| Application Number  | PT8TT134                                            |
| Development Address | R445 Carraigeway birdhill Gortybrigane and Birdhill |

Ref: Part 8 Proposed Birdhill Active Travel Scheme.

With reference to Section I, Figure 6-13 Layout Plan & Figure 6-14 Cross Section of the above proposed scheme, I hereby outline some concerns I have re impact on my entrance and front boundary fence.

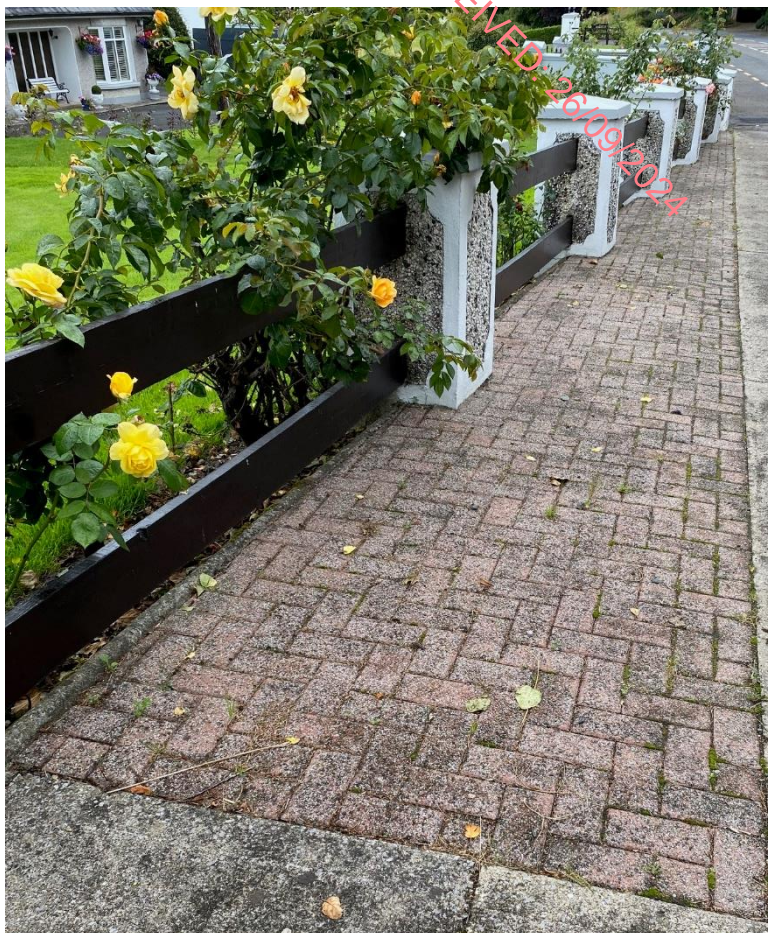
1. I am not clear about the proposal for the existing footpath and paved area outside my boundary fence. Figure 6-13 Layout Plan shows a new pedestrian footway on this area, while Sheet 2 of the General Arrangement indicates retention of the existing footway.
2. I am not happy that the fall from the edge of the proposed cycletrack to my gate will be  $\frac{1}{4}$  m, thus increasing the slope by 90mm, i.e. almost doubling the gradient from existing to proposed (as shown on Cross Section I below).
3. I note that a “cycle-friendly gully is to be provided at the back of the cycletrack.” Is that just one gully? Where will it be located? Where will the outflow from this gully be taken? I request that a continuous ‘aco drainage channel’ (or similar type) be inserted to run along my boundary fence to collect run-off surface water.

5. Can you clarify what the figures on the Plan alongside the pillars on my front boundary fence are (ranging from 41.54 to 40.89 on the extract from Sheet 2 of the General Arrangement below)? Do they show the height of the existing kerb, or the paved area, or the ground-level inside the fence, or the proposed finished level of the new path?

Can you also confirm whether the existing kerb and paved area will be left in place?

6. If the existing levels outside the fence are being raised, I will require that the levels of my piers and timber rails are also raised accordingly.
